State of the Art, Inc.

Thin film MIL-PRF-55342 termination material B (solderable) metal voids

Figure 1. Devices with end face metal voids reported by our customers.

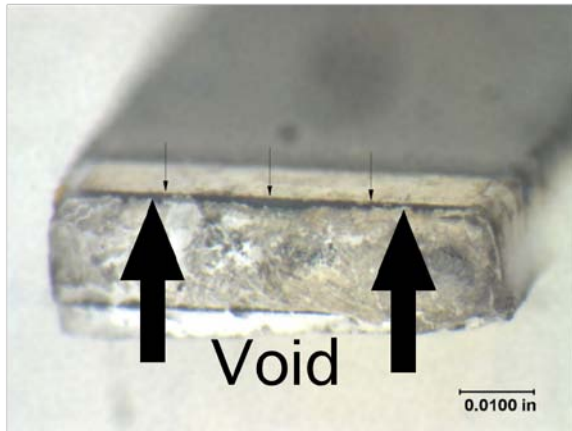
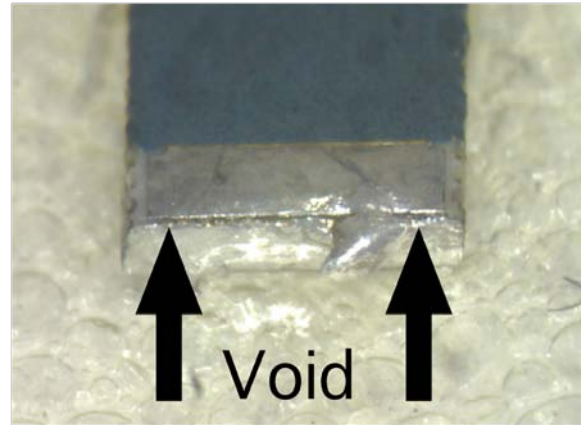
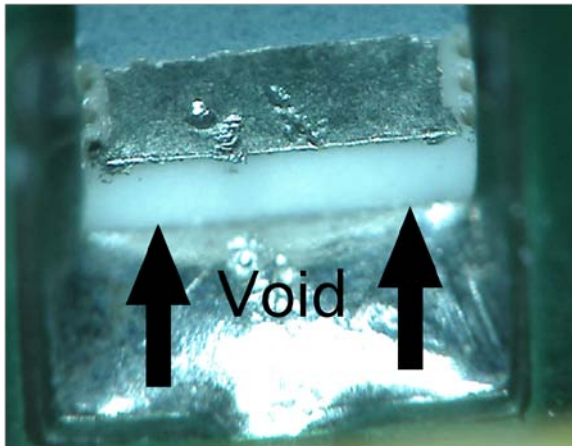
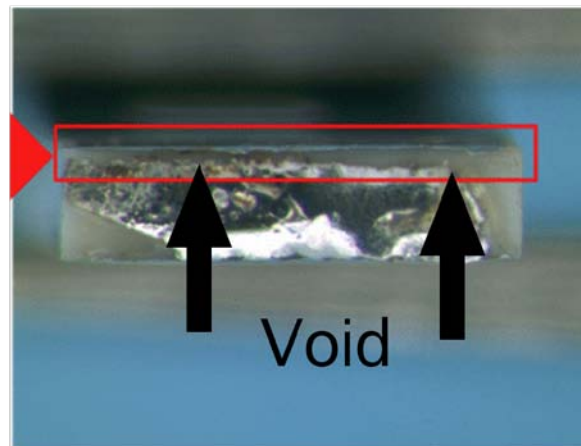
Three customers have reported a total of four thin film B termination material MIL-PRF-55342 devices exhibiting open circuit conditions after reflow solder mounting (Figure 1). All four devices were identified by routine electrical and visual inspection of the mounted devices. The assembly failures were reported on Feb. 5th 2009, August 31st 2010, Oct. 19th 2010, and February 14th 2011. No post assembly failures have been reported, nor have there been any life test failures. (*The thin film devices in question are identified by B termination material and either characteristic symbol E and H or resistance tolerance and multiplier symbols A, B, and C (0.1%).*)

The investigation of the affected lots indicates that the cause of the termination failure is due to voids in the end face metal. The cause of the voids is foreign material contamination preventing the adhesion of the sputtered TiW material to the alumina substrate. The foreign material was identified as potassium contamination from the cascade rinse tank used prior to the wraparound process. Our wraparound construction consists of sputtered TiW and gold, followed by electroplated Ni and SN60 solder (Figure 2).

The voids are not visible prior to soldering, but a post assembly visual inspection will reveal the defects. A screening process has been developed using hot solder dip and 100% visual examination to remove devices that have the propensity for voiding. As of January 17th 2011 all shipments of thin film MIL-PRF-55342 solderable devices have been screened to mitigate the shipment of potentially defective devices.

A revised pre-wraparound cleaning and inspection procedure was implemented on January 28th 2011, and the results indicate that the end band voiding has been eliminated. To date 57,611 pieces of the revised cleaning procedure have been assessed with no defectives found. We will continue to sample a significant portion of current production to assure end band termination quality. In addition, we are pursuing alternative construction for the wrap around process to simplify the process, make visual examination of the base layer metalization stack possible, and provide a more robust product.
